**ACOUSTIC FENCE DESIGN REVIEW
FOR
SILVERDALE HOUSE
PUMP LANE
HAYES**

AIRO has been appointed to review the current design proposals for an acoustic fence to be located along the site boundary of Silverdale House, Pump Lane, Hayes.

A planning decision notice issued by the Council of the London Borough of Hillingdon, in association with planning application reference 49670/APP/2022/974 and dated 10 June 2022, sets out in Condition 5 that an acoustic fence with height not exceeding 3 metres above ground level is permitted.

Figure 1 – Location Plan with Proposed Acoustic Fence Position Indicated

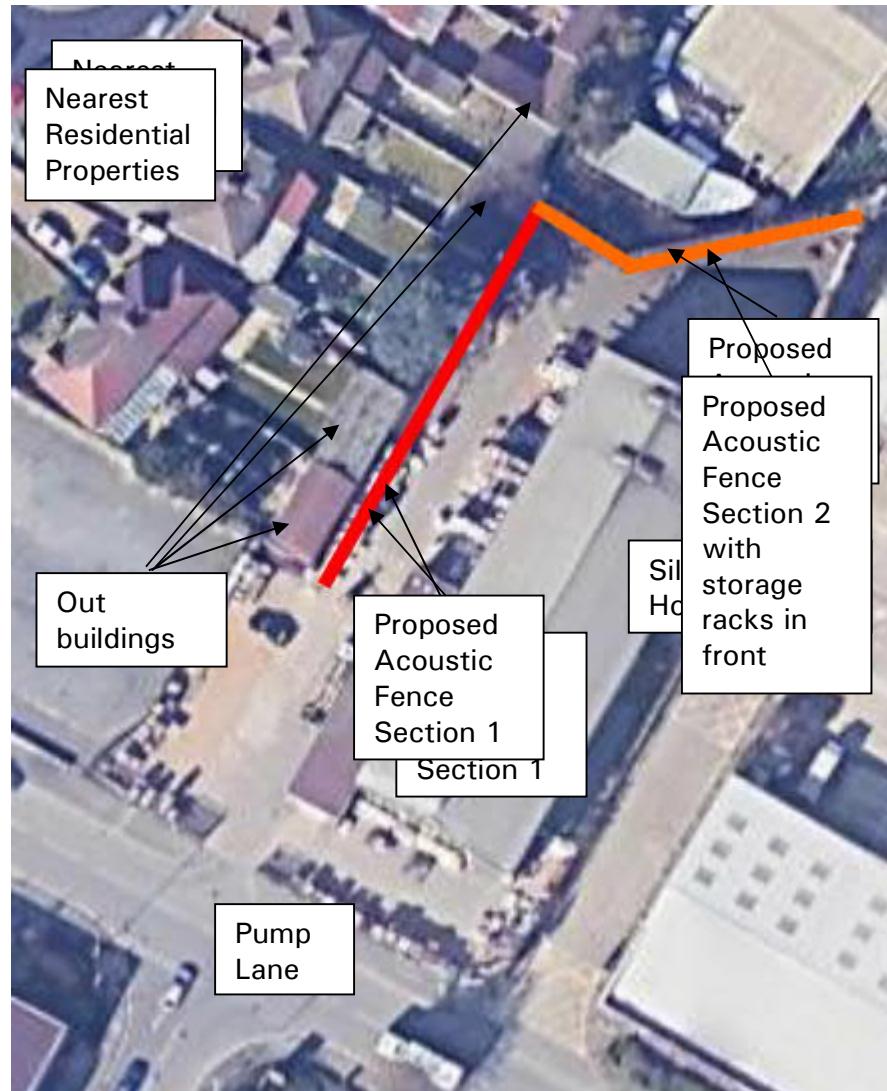
Figure 1 provides a site plan indicating the proposed fence location and the locations of the nearest residential properties.

On the residential side of the boundary are a number of masonry built sheds / outbuildings that are approximately 3.4 metres high. It may be noted that two gardens, adjacent to Section 1 of the proposed fence, do not include outbuildings.

Figure 3 – Noise Level Contour Difference Plot for Position 1 with 2 metre source height and 1.5 metre high receivers

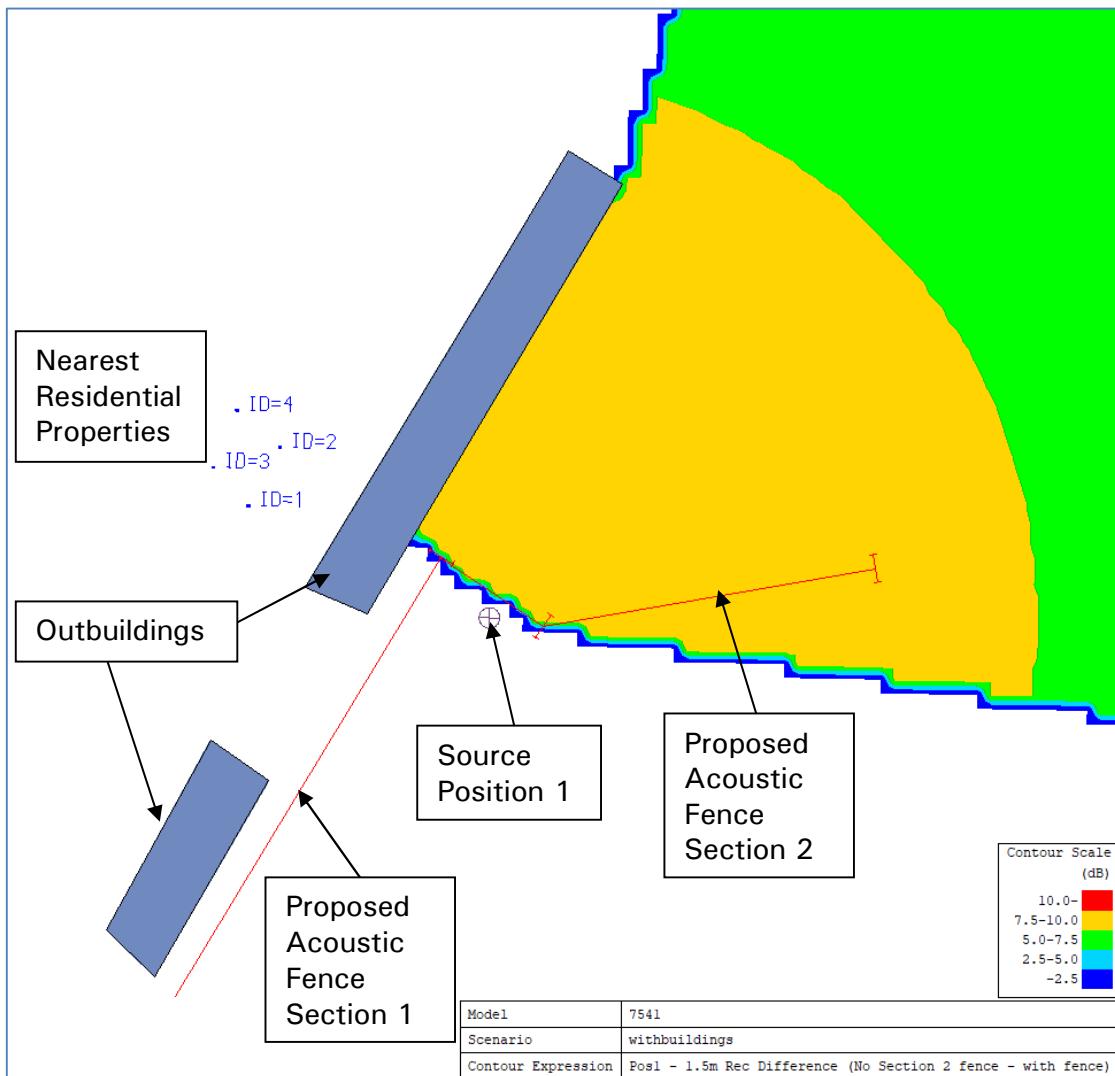
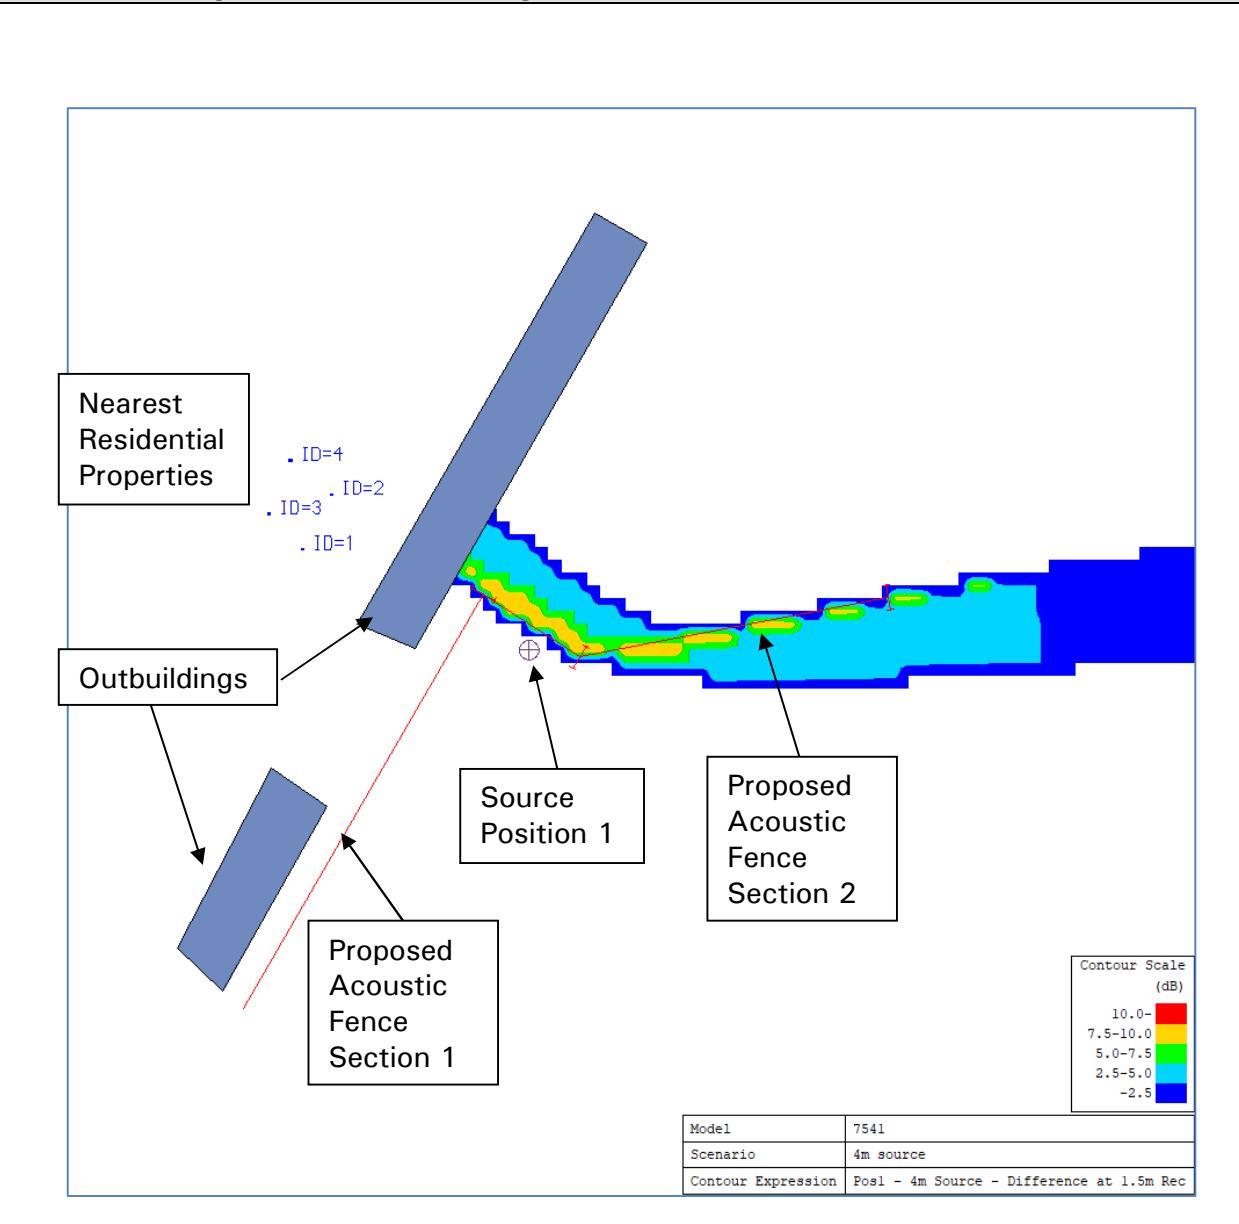
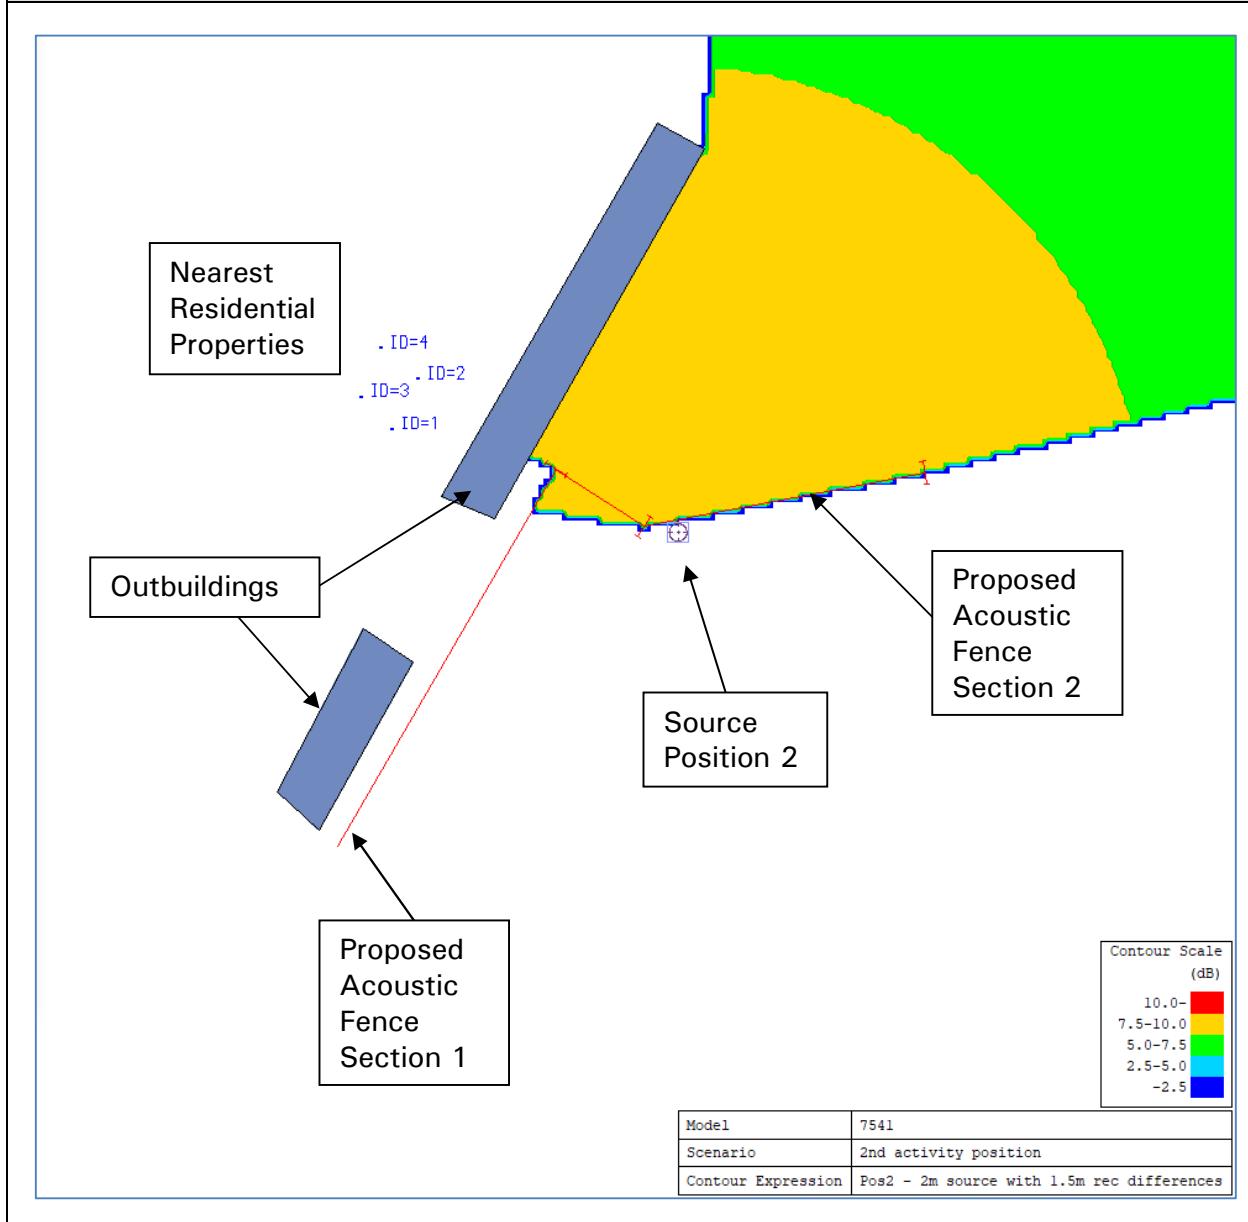
For Source Position 1, with a source height of 2 metres and receiver height of 1.5 metres, the results indicated that there would be no change in noise level within the gardens of the nearest residential properties with or without the Section 2 fence. Figure 3 provides the contour difference plot showing the change in noise level. The gardens are located between the outbuildings and nearest residential properties.

For all of the contour difference plots the areas with a white background indicate no change in noise level. Positions denoted as ID=3 and ID=4 are at the façade of the nearest residential properties, whilst ID=1 and ID=2 are within the gardens.

Figure 4 – Noise Level Contour Difference Plot for Position 1 with 4 metre source height and 1.5 metre high receivers

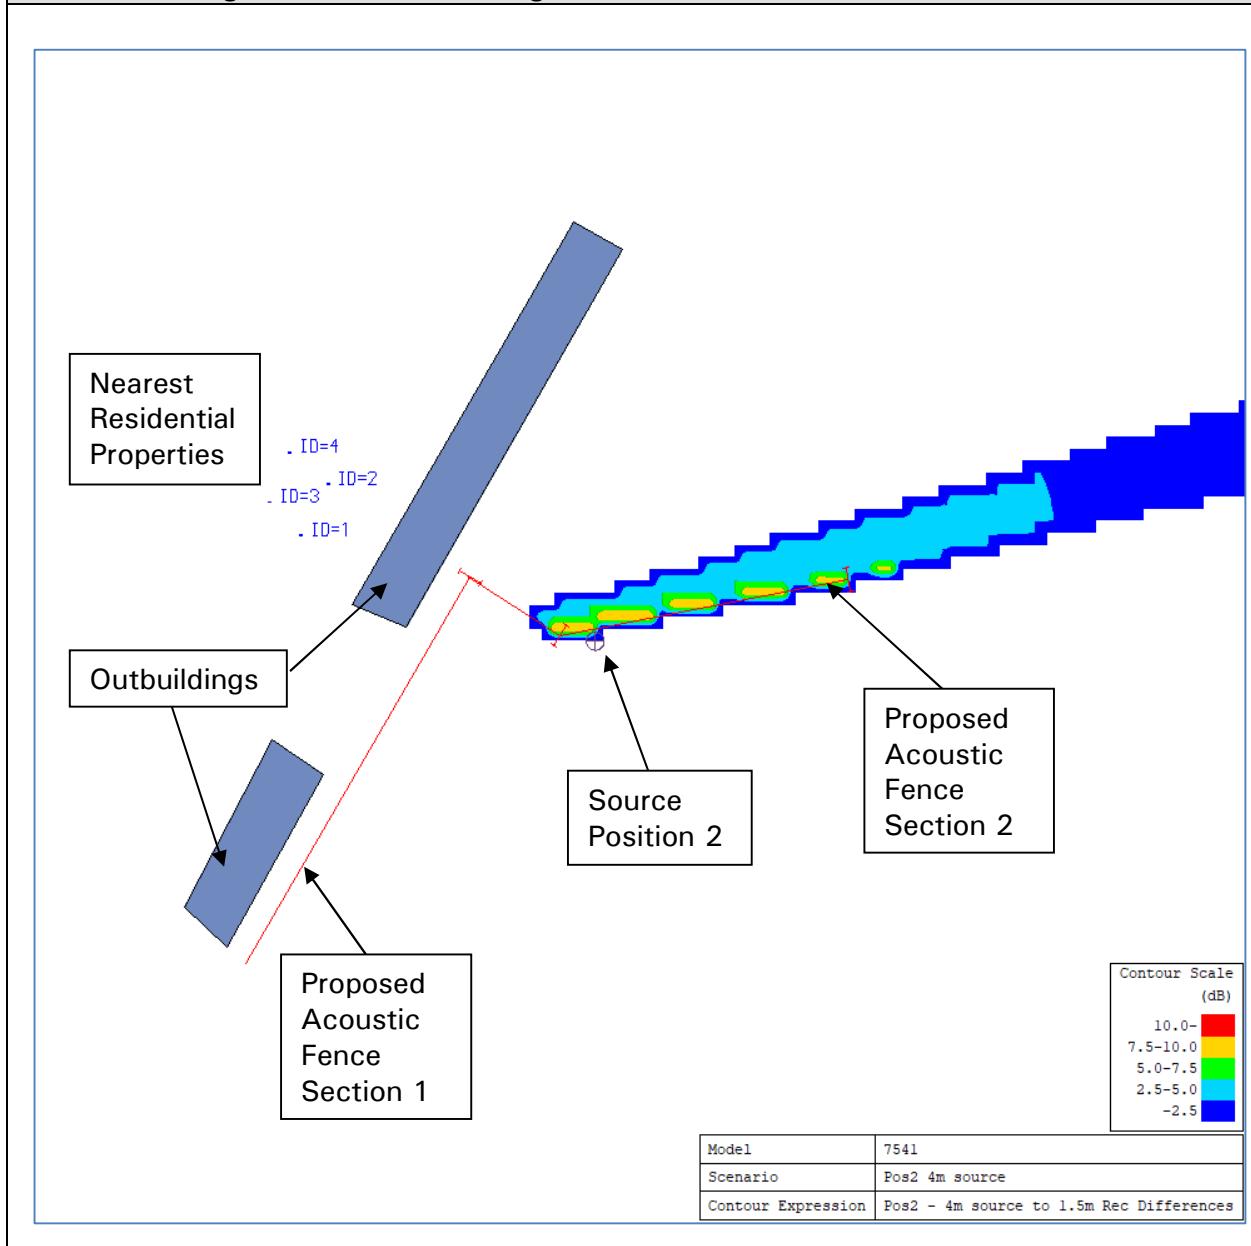
Figure 4 shows the contour difference plot for a 4 metre high source at Position 1 to receivers at 1.5 metres over local ground. Again, there is no difference in the gardens of the nearest residential properties with the only differences being very close to the Section 2 fence.

For Position 1 the noise levels at ID=3 and ID=4, first floor level in front of the façade of the nearest residential properties, there is similarly no change in noise levels with Section 2 of the proposed fence present or absent.
